County of Fairfax, Virginia

STAFF REPORT ADDENDUM

RZ 2022-SU-00019
SE 2022-SU-00038

PROPOSAL: Rezoning from the I-3, I-5, and C-8 Districts, with overlays, to the I-5 District, with overlays, to permit a Data Center with an FAR of 0.8 (Option 1) or a Warehouse with an FAR of 0.3 (Option 2), and a Special Exception for an increase in building height in the I-5 District from 75 to 110 feet pursuant to Zoning Ordinance Section 5100.2.E(4).

**GENERALIZED DEVELOPMENT PLAN
 OPTION 1**

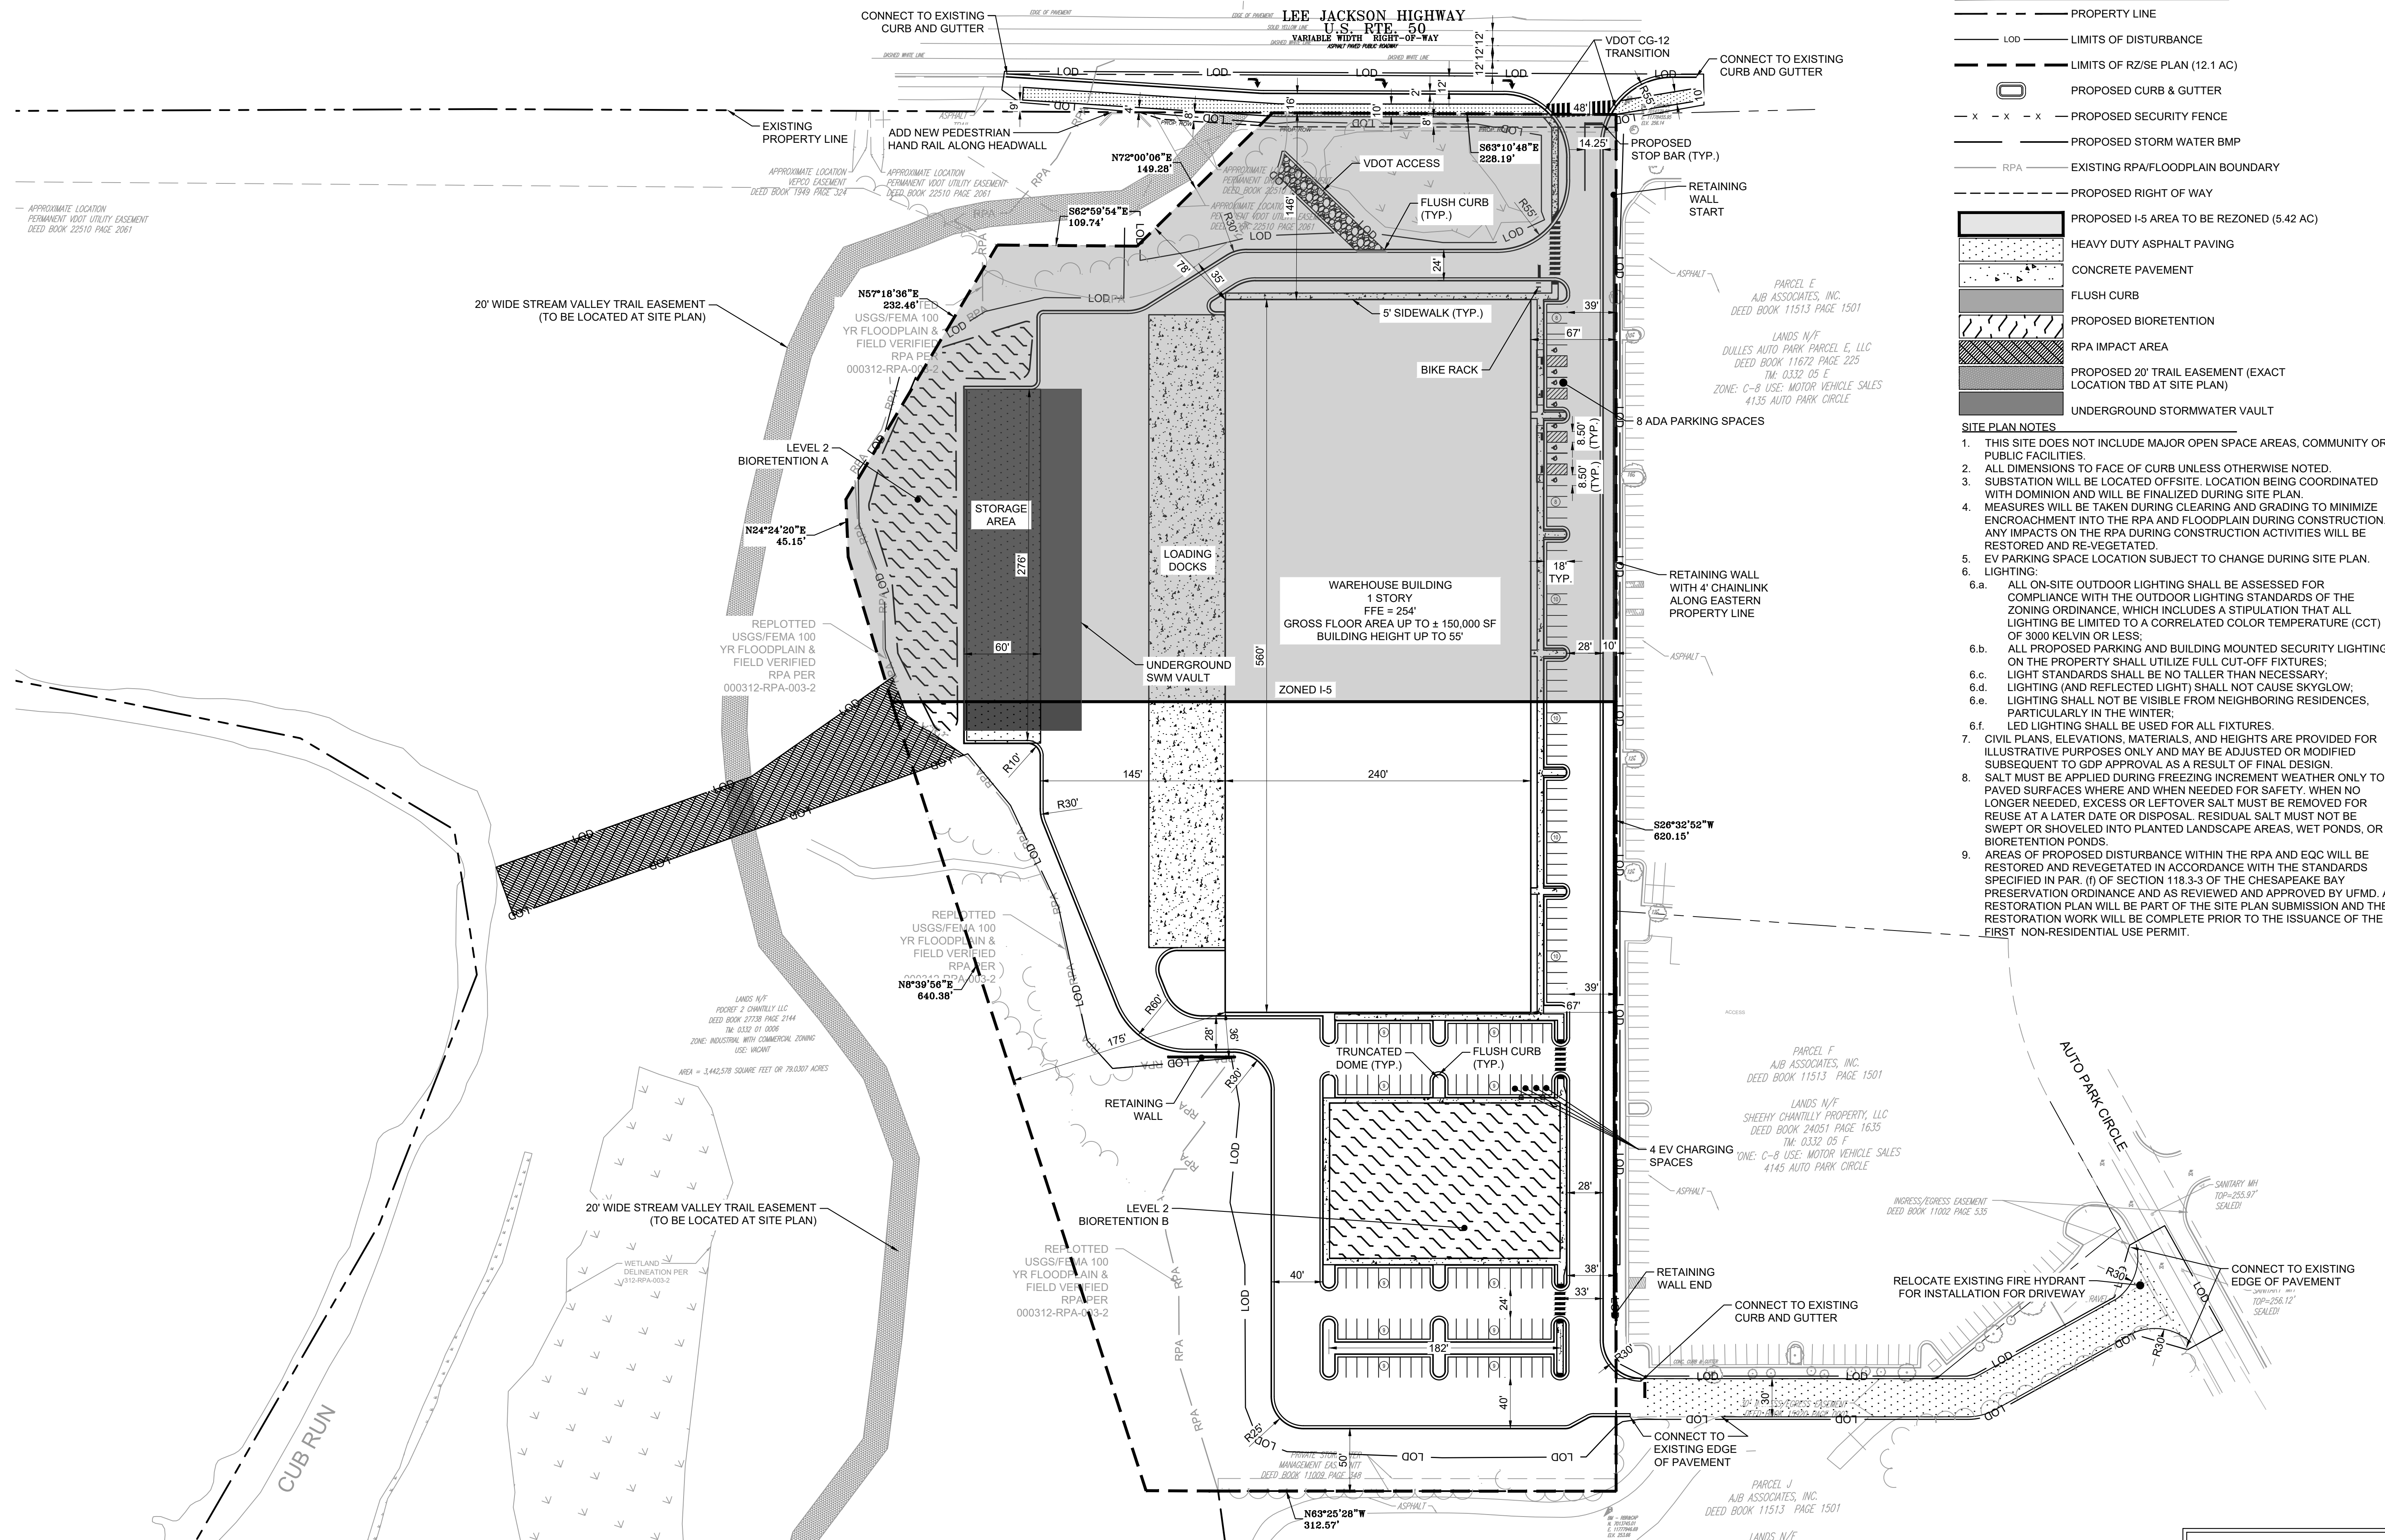
Sheet C-100 states that areas of proposed disturbance in the RPA will be restored and re-vegetated in accordance with 118-3-3; the note about the disturbance in the RPA, is just for the outfall; a water quality impact assessment will be required in the plan for the outfall.

**PRE-DEVELOPMENT
 DRAINAGE AREA MAP
 OPTION 1**

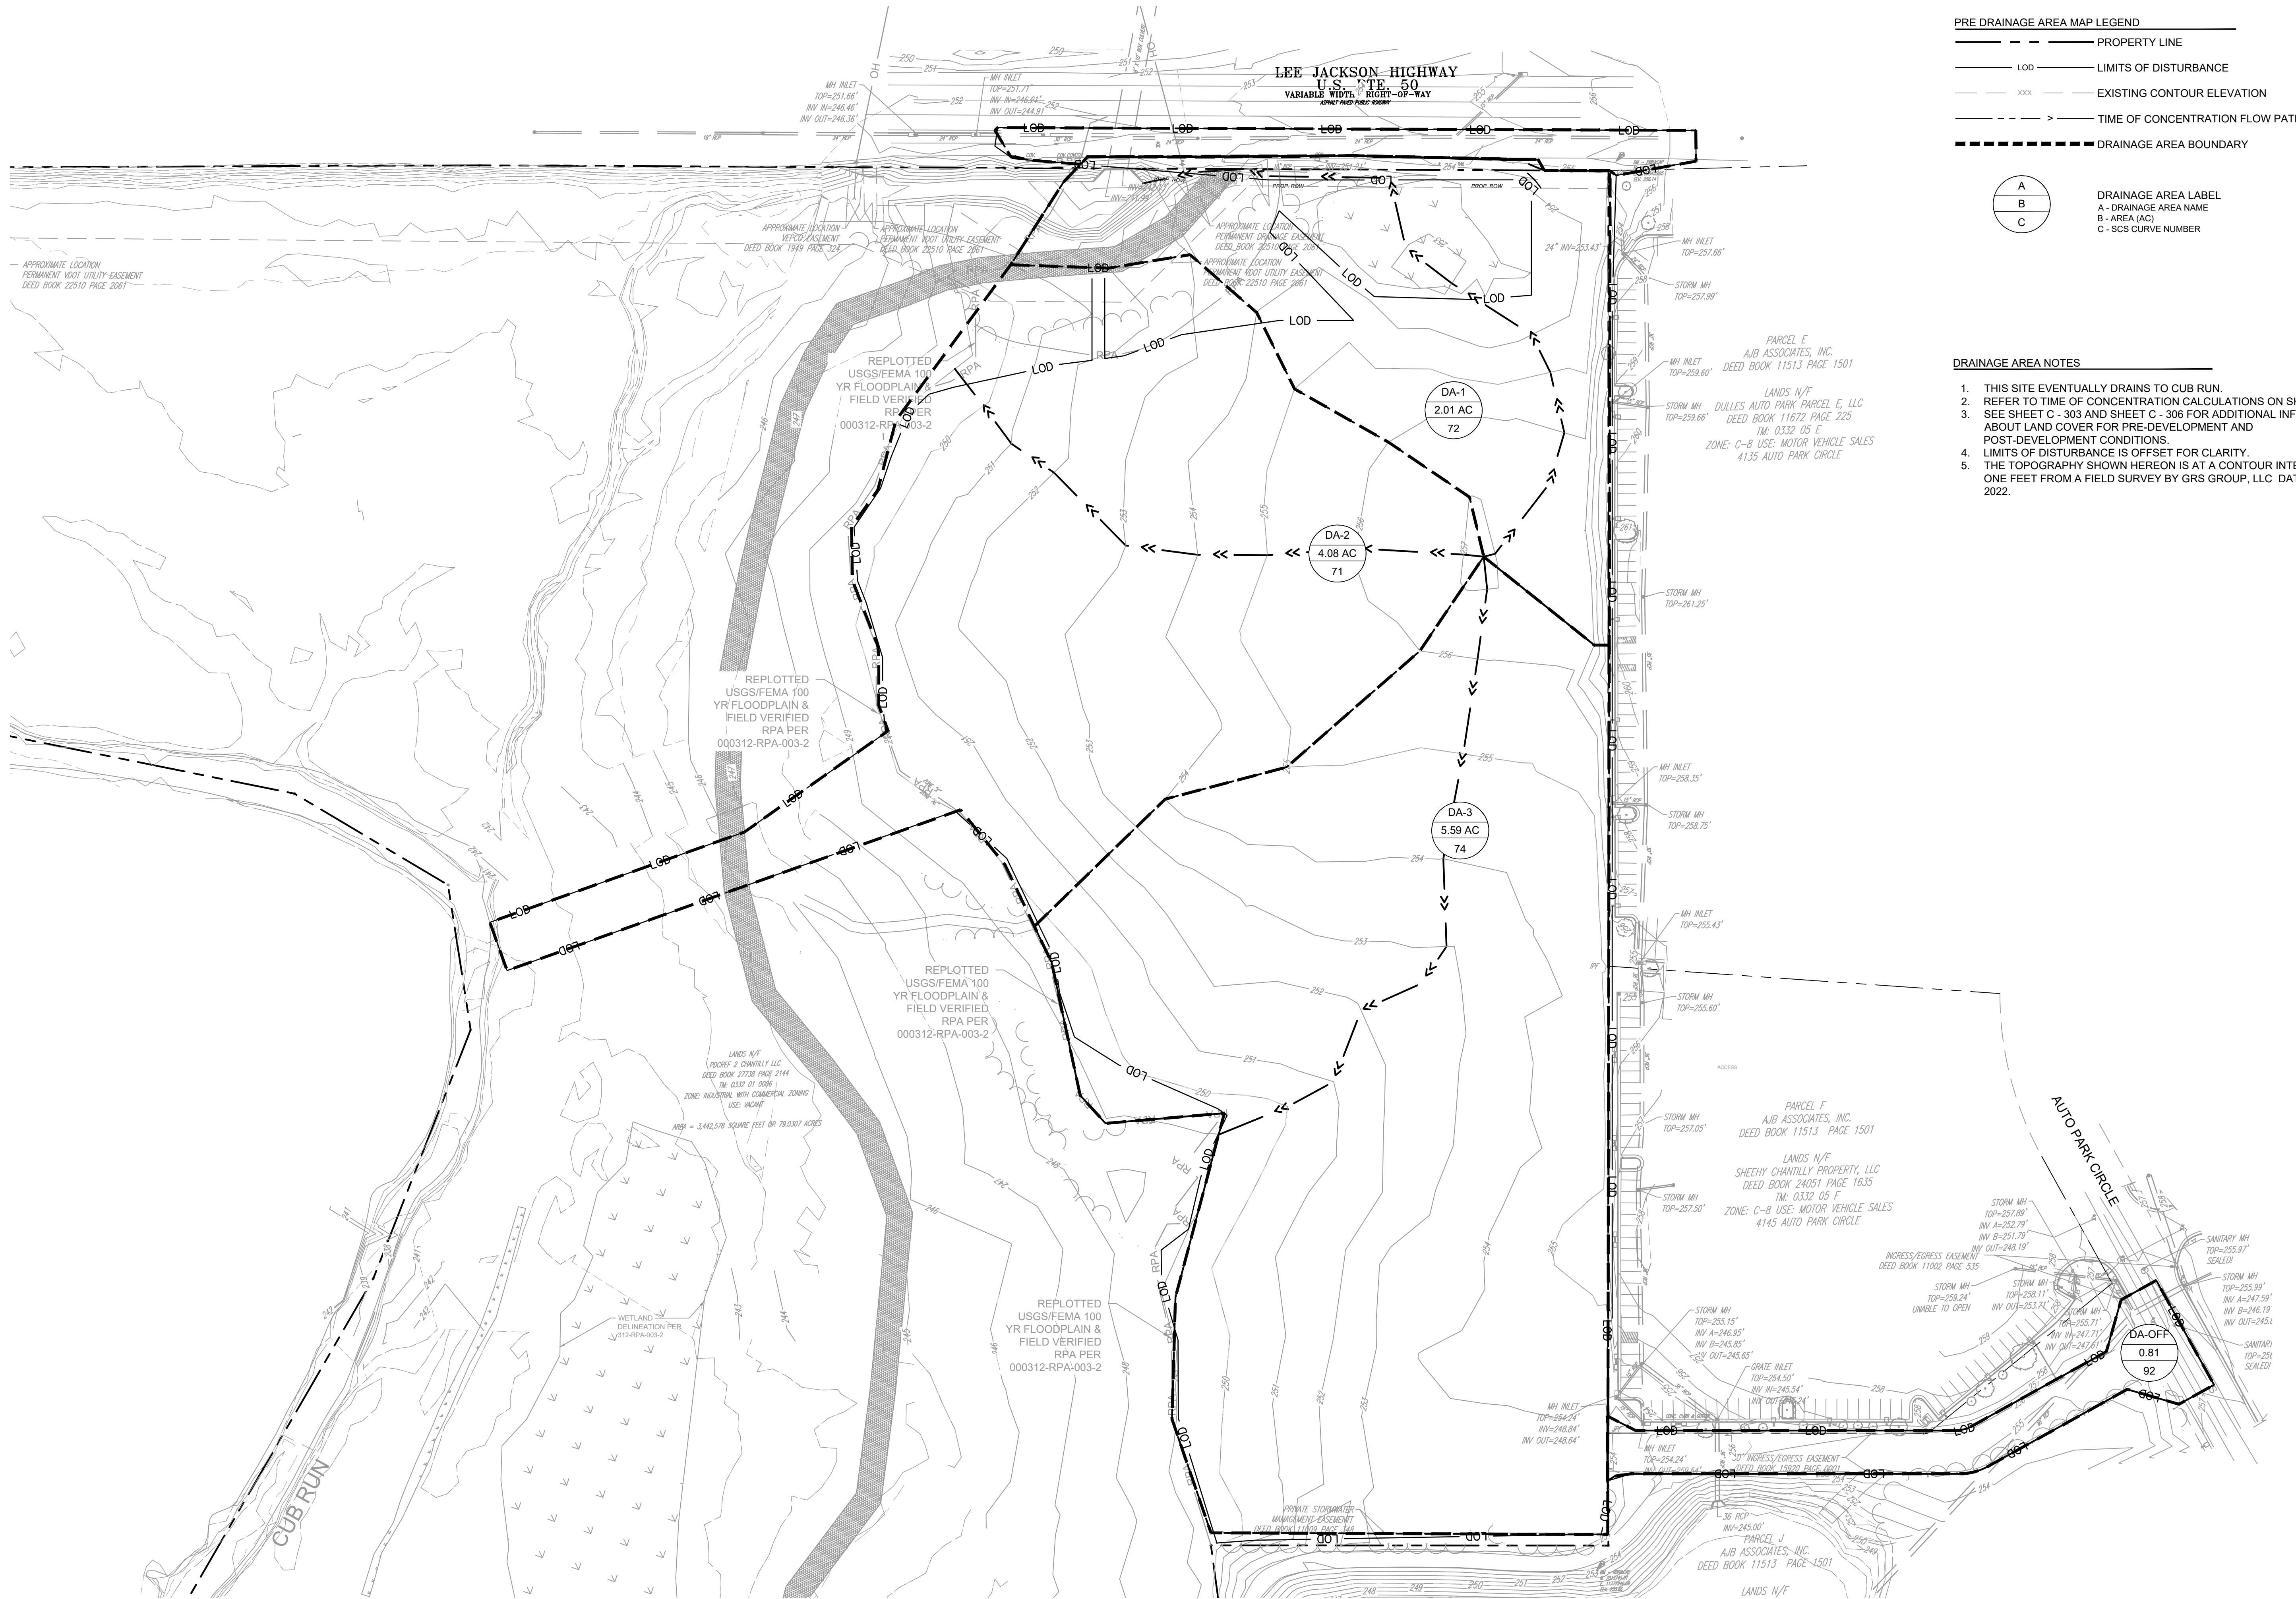
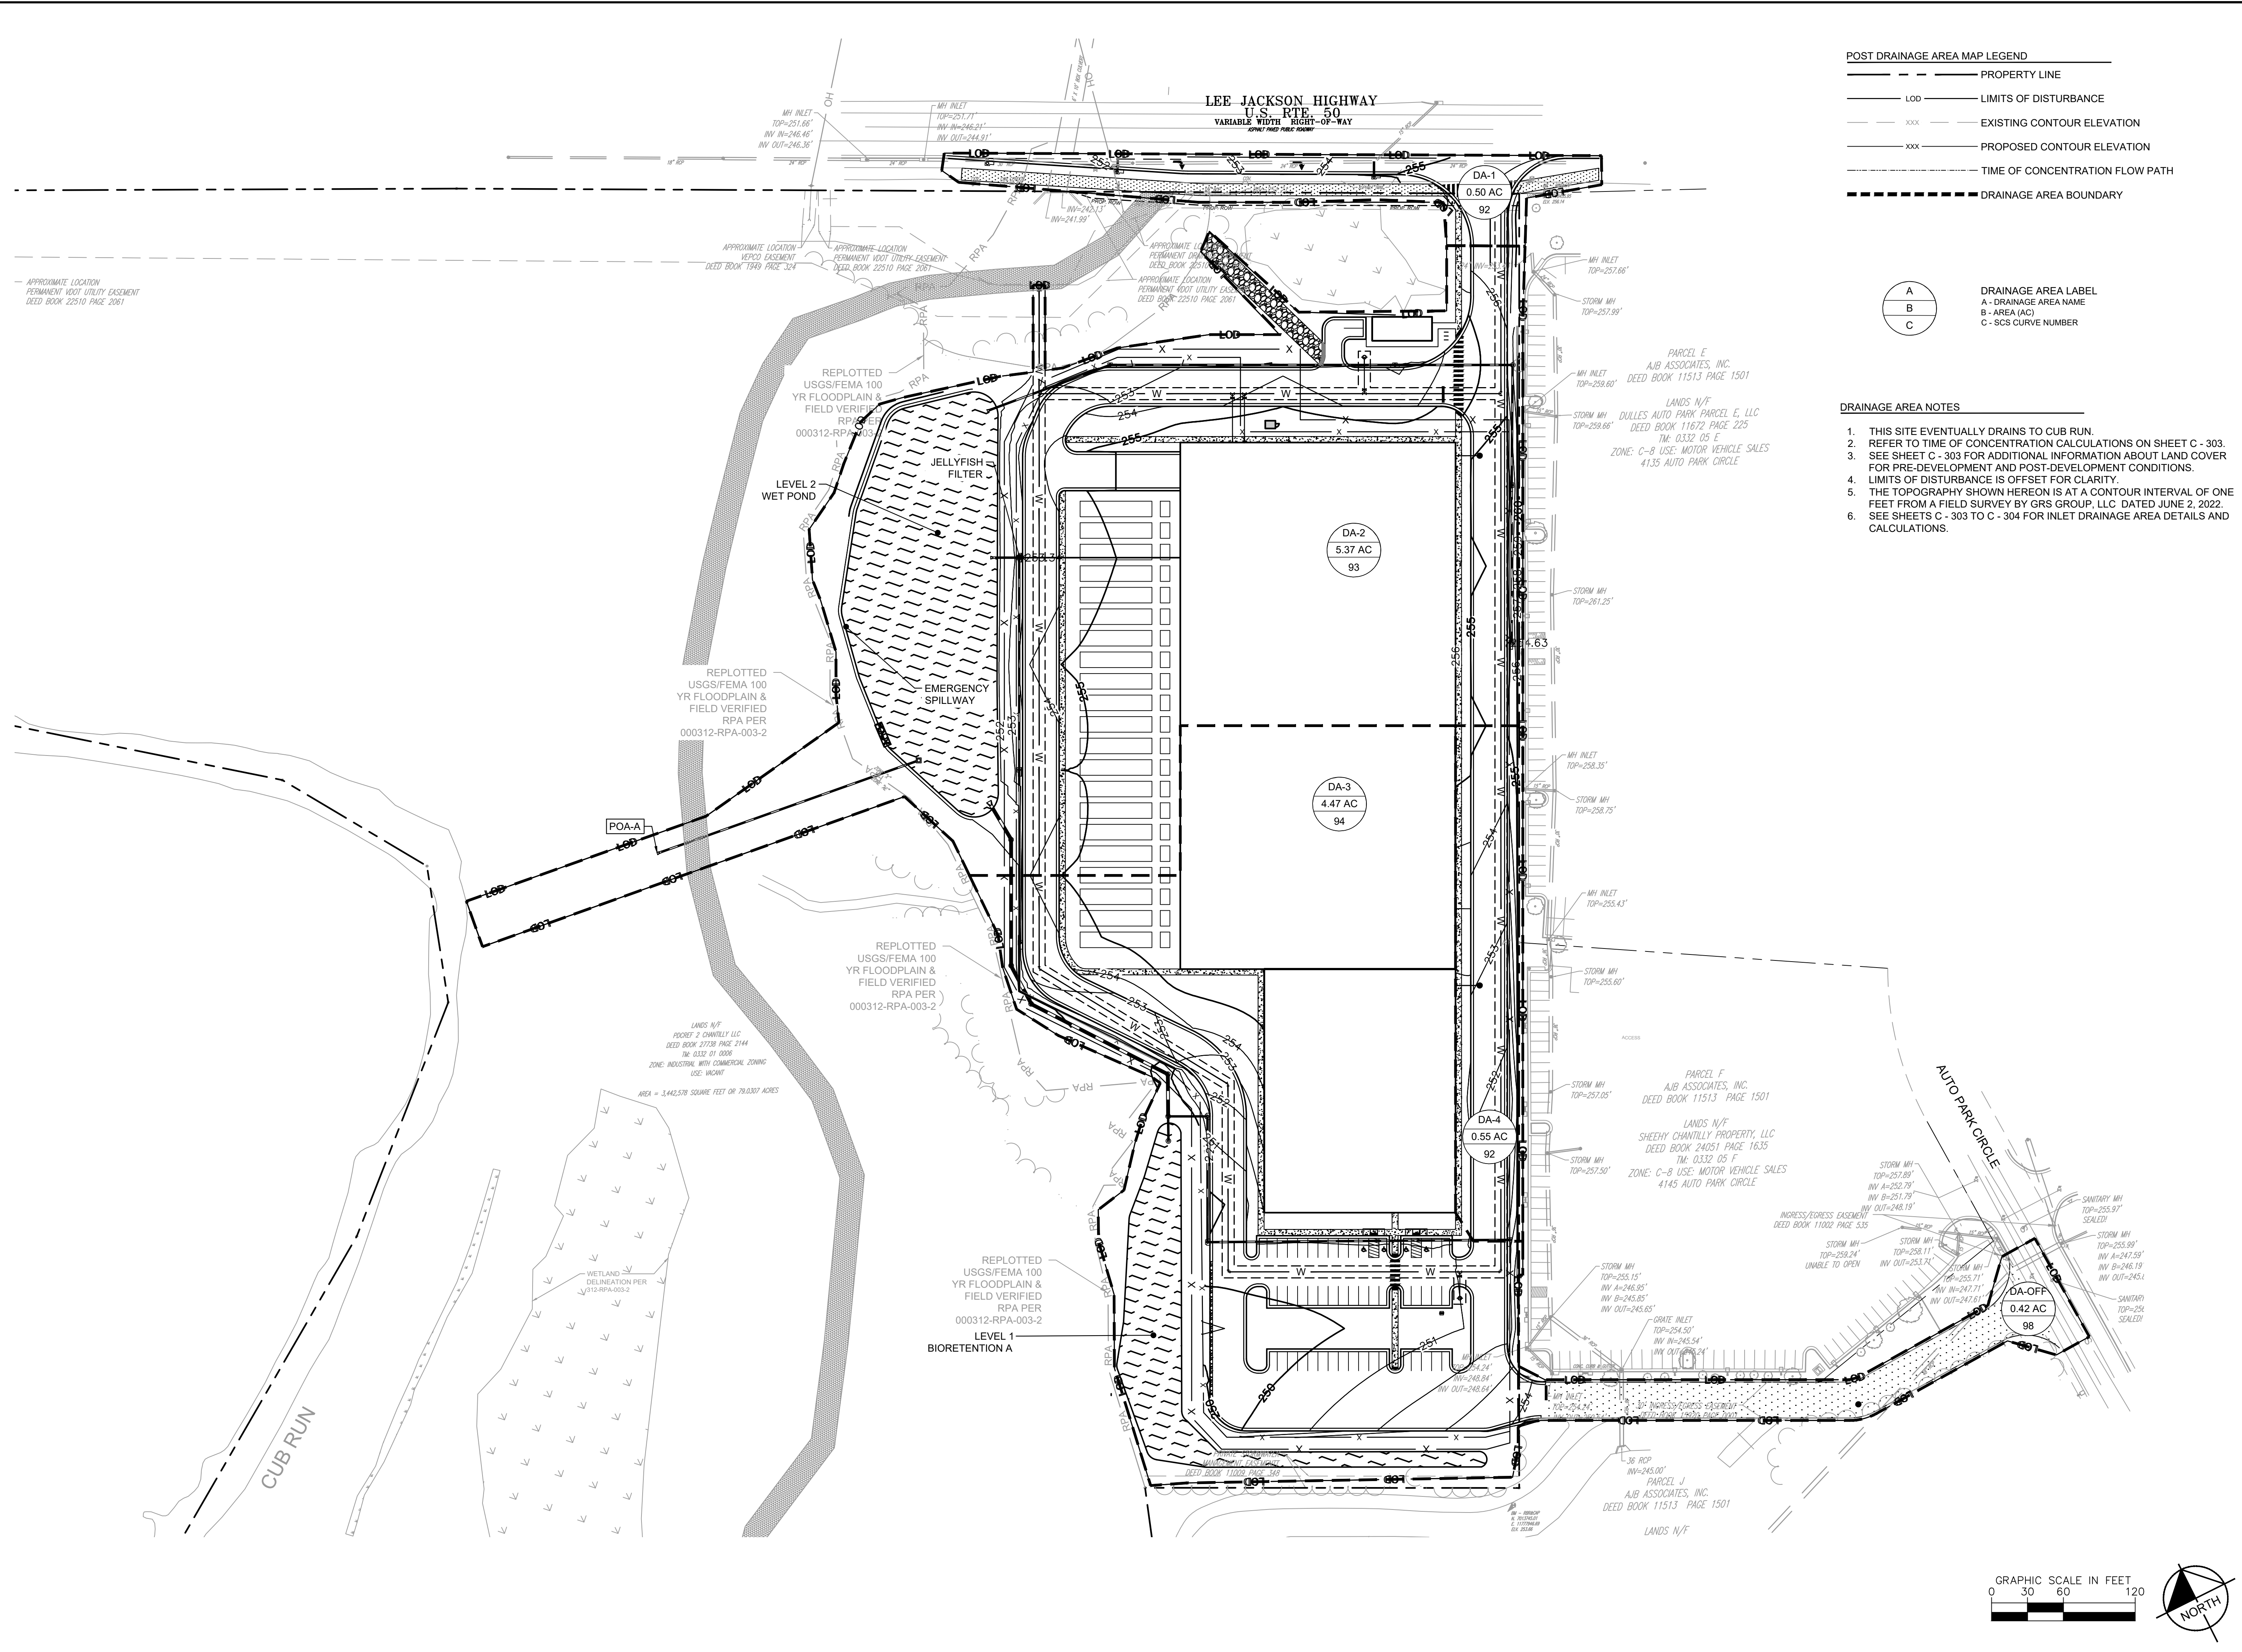
Water quantity controls for stormwater detention are required for this project per SWMO 124-1-6, 124-4-1, and 124-4-4.D. The entire site is wooded, see the CN number on sheet C-300 and C301; the applicant is providing detention to forested conditions
